30-015-33929
Poker Lake Unit #227
BOPCO, L.P. 626073

**Re: Notice of Application to Amend
Authorization SWD-1064
Poker Lake Unit #227
Eddy County, New Mexico
File: 100-WF: PLU227.C108**

APPLICATION FOR AUTHORIZATION TO INJECT

LEASE: POKER LAKE UNIT

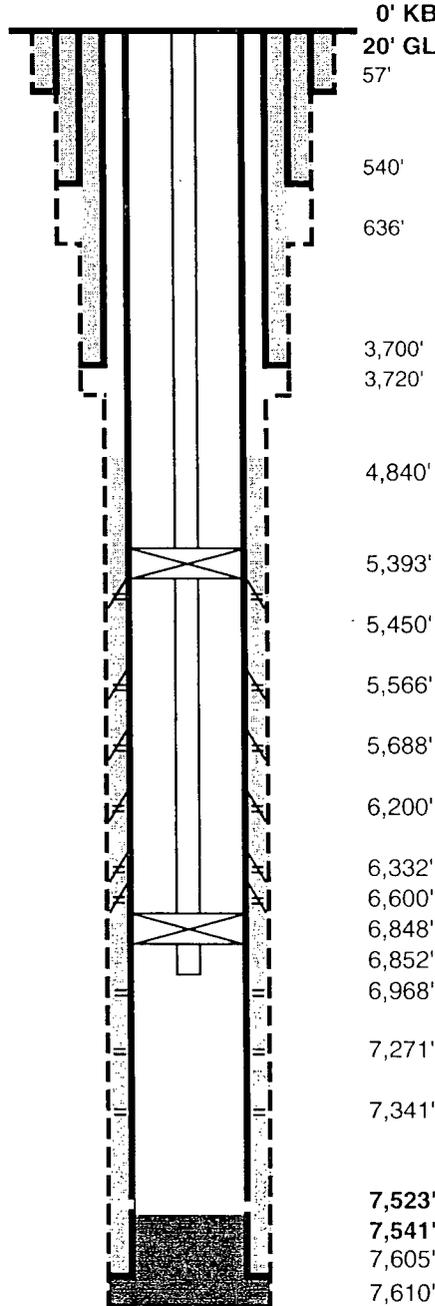
Has Bepco considered running a Step Rate Test to obtain an increased disposal pressure limit? This could potentially enable Bepco to dispose of enough water that the expensive recompletion to an upper interval would not be necessary.

Thank you for the suggestion, but the problem with the well was not a need for more pressure. The problem is that the current disposal interval and the perms we have squeezed in the past, are in communication with our Horned Toad 36 State #1H producing well in T25S, R29E, Sec. 36. We are trying to utilize the well-bore for disposal with what we have to work with.

LEASE: POKER LAKE UNIT WELL #: 251H HORIZONTAL
 FIELD: NASH DRAW (DELAWARE)
 LOCATION: SL: 1980' FSL & 785' FEL, SECTION 30, T24S, R30E
BHL: 1626.6' FNL & 2275' FEL, SECTION 30, T24S, R30E
 COUNTY: EDDY ST: NM API# 30-015-34404

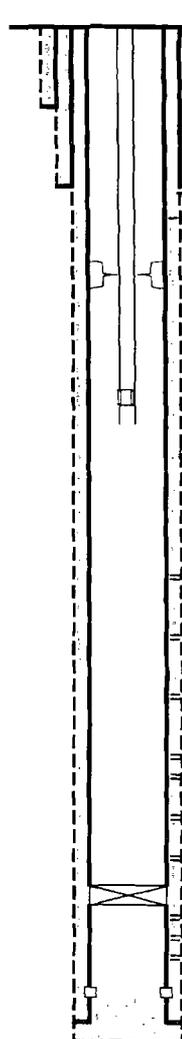
- 1) Send formation tops from the Rustler top to the Bone Spring
- 2) The offsetting horizontal well has a reported cement top that is lower than BEPCO's planned perforations in the subject well. Please send a well bore diagram of the horizontal well showing cement placement and casing and mark the TVD top of the Delaware on the diagram. Is BEPCO willing to lower the planned injection perforations or squeeze cement the Horizontal well?
- 3) How does BEPCO plan to test the upper Delaware in the subject well for hydrocarbon productivity? Or how do you know it does not need to be tested?
- 4) Is there any offsetting production in this upper Delaware? How far away?
- 5) Why does the Newspaper Notice include slightly different proposed intervals than the application?

1. See attached formation tops for the PLU 227 ✓
2. See attached well-bore sketch with the top of the Lamar and Bell Canyon marked. ✓
3. BOPCO, L. P. does not plan to test the upper Delaware for hydrocarbons as our petro-physical analysis of these zones indicates that they are wet. ✓
4. The PLU 68 is producing from the upper Delaware at 4376-88' and is approximately 7 miles away. ✓
5. The newspaper article was done based on the initial information my supervisor gave me. When he chose the actual perfs, they were slightly different, but within the overall interval I had advertised. ✓

I forgot the second part of your 2nd question. We will exclude the perms at 3800-30', that correlate to the TOC in PLU 251H, The top set of perms will be 4044-64'.
